CHUCK E. CHEESE'S

6130 EAST SPEEDWAY - TUCSON, ARIZONA - 85712

UNIT NO. 3197

INDEX OF DRAWINGS

ROOFTOP HVAC UNIT SCHEDULE

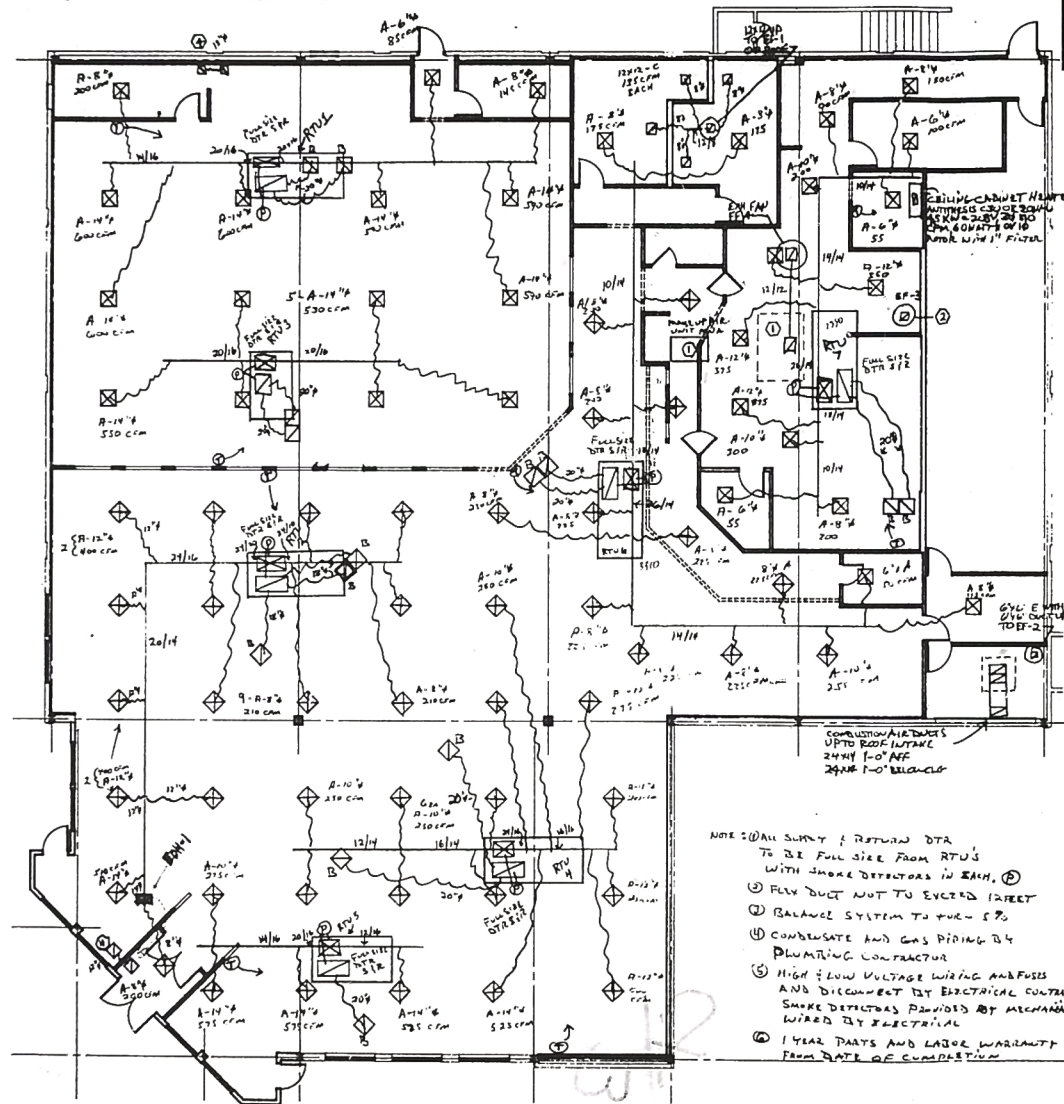
REVISED PER ADDN. SEE SUBMITTALS

REVISED SCHEDULE

Mark	Location	Equipment	Carrier Equipment
RTU-1	GC316-1400	4000 cfm	487TD014-SCA 5000 cfm
RTU-2	GC316-1453	4400 cfm	487TD016-SYA 4000 cfm
RTU-3	GC316-1353	3300 cfm	487TD012-SGA 4000 cfm
RTU-4	GC316-1400	4000 cfm	487TD014-SCA 5000 cfm
RTU-5	GC316-823	2000 cfm	487TD007-S 2400 cfm
RTU-6	GC316-1353	3300 cfm	487TD012-SGA 4000 cfm
RTU-7	GC316-1353	3300 cfm	487TD012-SGA 4000 cfm
		24000 cfm	30400 cfm

TYPICAL LETTER SECTION - U.L.

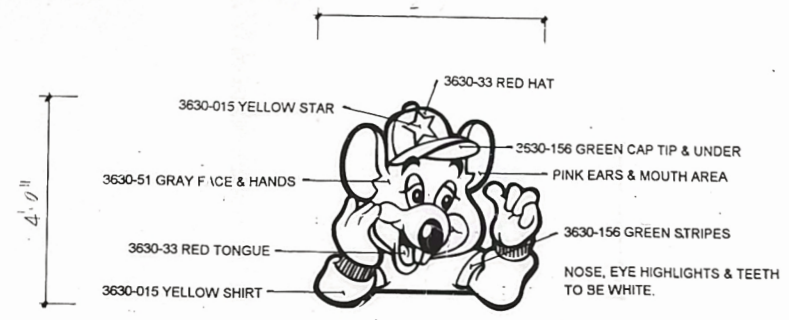
APPROVED
DATE 4-11-95
Sign Inspector
see comments & details
(1) well sign

ALL UNSWITCHED PRIMARY CONDUCTORS INSIDE OF BOXES MUST BE INSTALLED IN ISOLATED METAL GROUNDED RACEWAYS
